### **BID ADDENDUM NO. 2**

September 17, 2018

## Johnson Student Center Building Demolition, Increment 1 (Demolition) and Increment 2 RANCHO SANTIAGO COMMUNITY COLLEGE DISTRICT SANTA ANA, CA

# DSA App. Nos. 04-116810-1 and 04-116810-2

SHEET TITLE SITE DEMOLITION PLAN ELECTRICAL

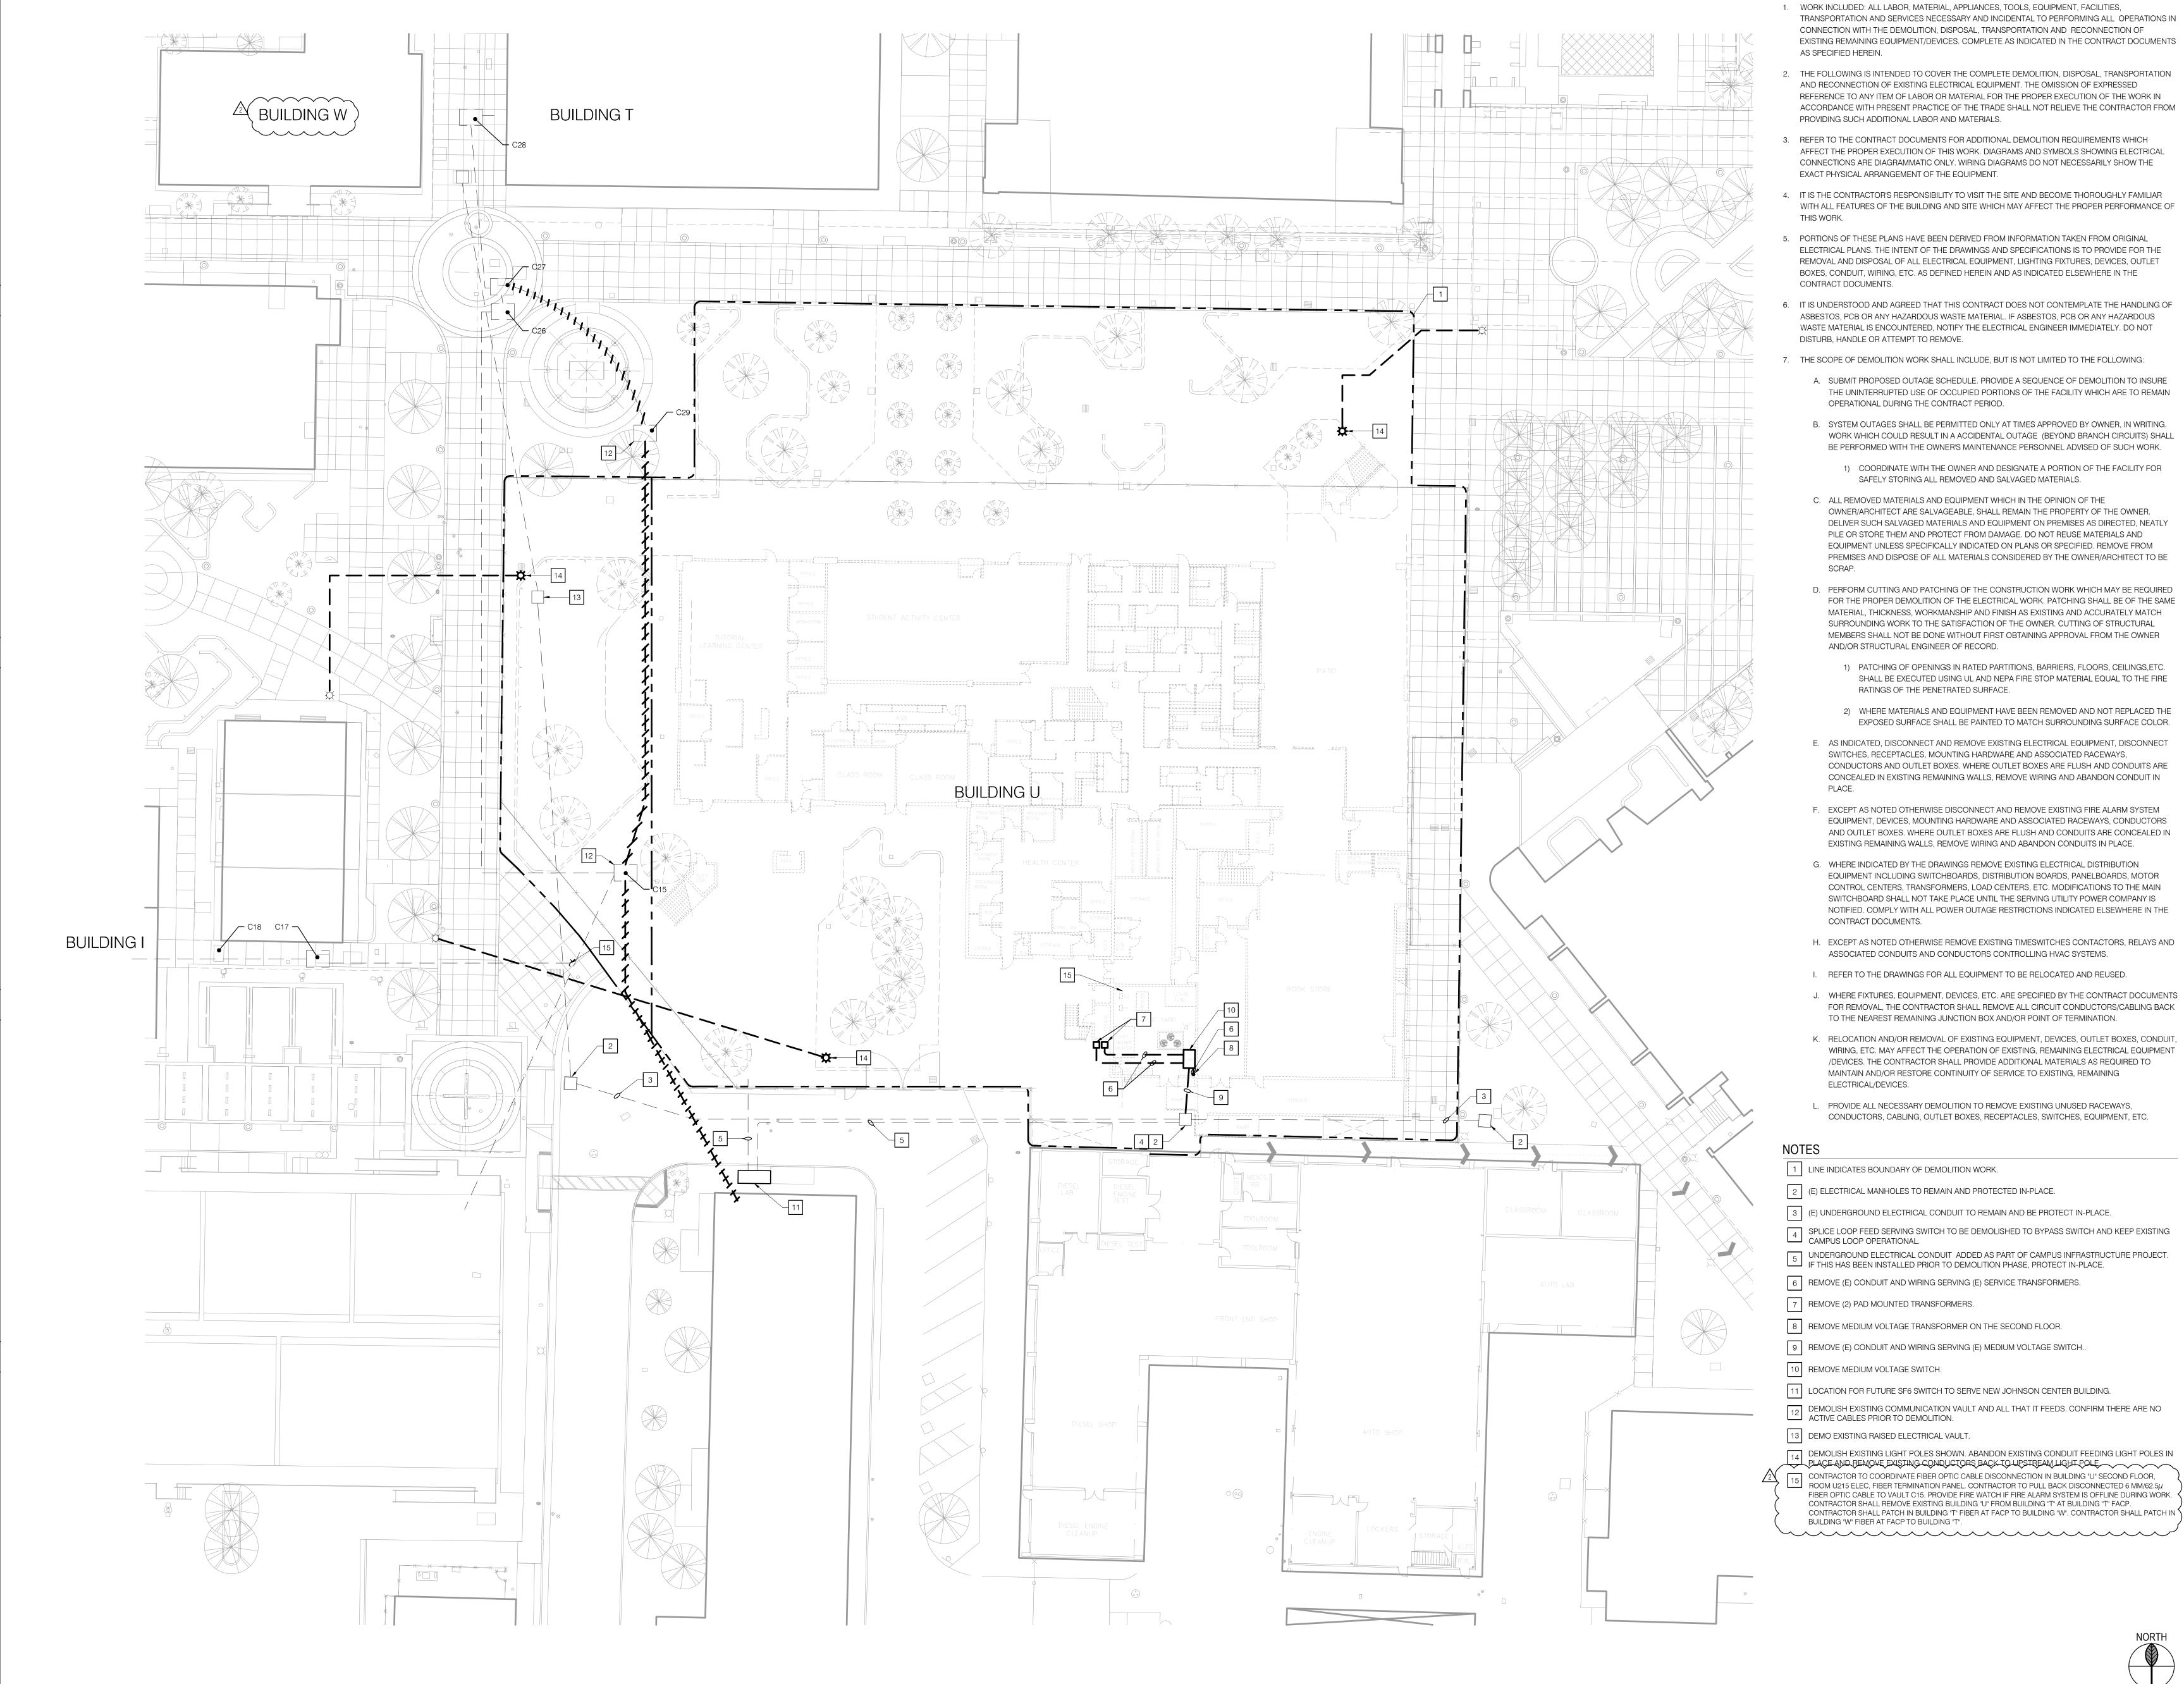
- Building Demolition
  - i. ED1.01 revised
    - 1. Revised Keynote 15: Fire Alarm
- Pre-Bid Clarification (PBC) Responses
  - PBC's 1 through 8 and 10

DATE:	9/12/2018							
FROM:	S.Monsen - McCa	arthy	EMAIL:	SMonser	n@McCarthy.com			
SPECIFIC	ATION NUMBER:		DRAWING N	IUMBER:	ED1.01			
REQUES	REQUESTED CLARIFICATION:							
Bldg Demo - Sheet ED1.01 - "Square" Notes 15 - Confirm that D4 Contractors are subcontracted directly by the owner.								
RESPON	SE TO CLARIFICATIO	ON, SUBMITTED AS PART OF AN A	DDENDUM:					
RESPONSE TO CLARIFICATION, SUBMITTED AS PART OF AN ADDENDUM: REVISED NOTE TO REMOVE "D4" CONTRACTOR AND TO READ "CONTRACTOR to pull back". REFER TO ATTACHED REVISED SHEET ED1.01.								
RESPON	ISE PROVIDED BY:	Melissa Klug, P2s		DATE:	09/17/18
